Subject: ENERGY STAR® criteria revisions

Thank you for allowing us the opportunity to provide input regarding the upcoming ENERGY STAR revisions. Taylor Building Products would like to submit the following comments for your consideration concerning the proposed draft side-hinged door criteria and analysis published on August 6, 2008:

Figure 1

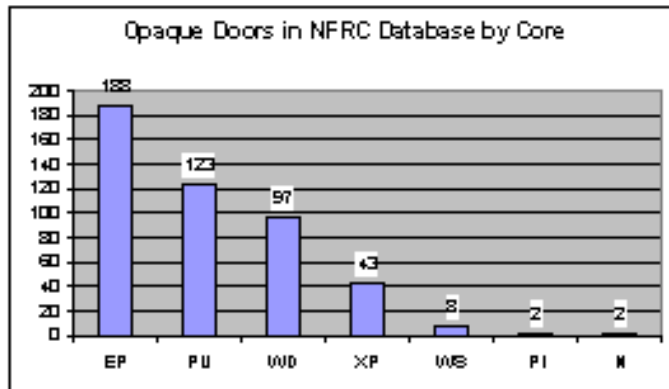
Taylor Building Products acknowledges that there is great opportunity for improvements in efficiencies with opaque door units. Opaque entry doors constitute a large percentage of the market. Therefore, we believe a more aggressive value for Phase 1 would better differentiate energy efficient products. Of the 463 opaque door records ($VT \leq 0.00001$) in the NFRC database, 237 of them already perform at 0.18 or better (Fig 1 and Fig 2). We believe this would be an appropriate value that is achievable with current technologies.
